Product Change Notice

Doc No. :PCN-EX-20166A

Subject: Increase the UART FIFO from 16 to 32 bytes

CTF ETF

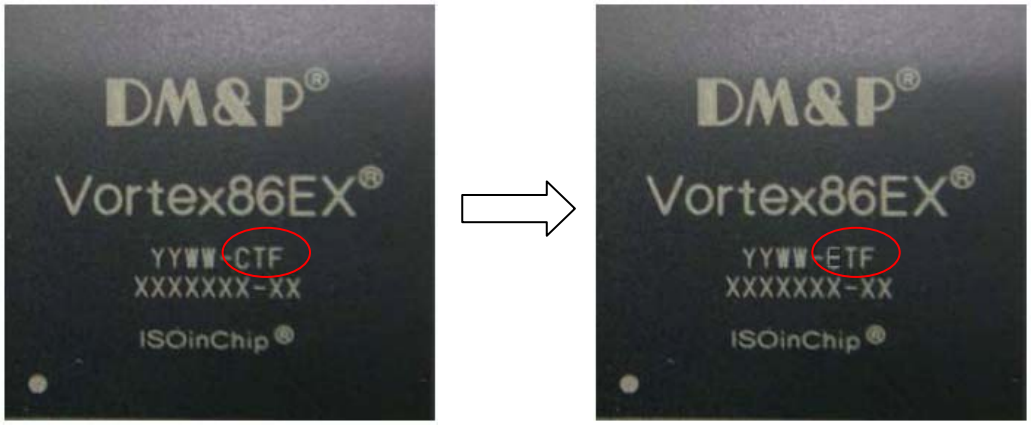
Content: In Vortex86EX ver:CTF, the FIFO of UART 1 to UART 8 is 16 bytes. The new version, ver:ETF, increase the FIFO to 32 bytes.

Top marking:
From CTF to ETF.

Ordering Part No.:
From VX86EX-9123 to VX86EX9123E

Effect :
Not any side effect from customer's hardware/software. Increase the FIFO is to avoid the data overflow when UART baud rate set to over 1M bit/s.
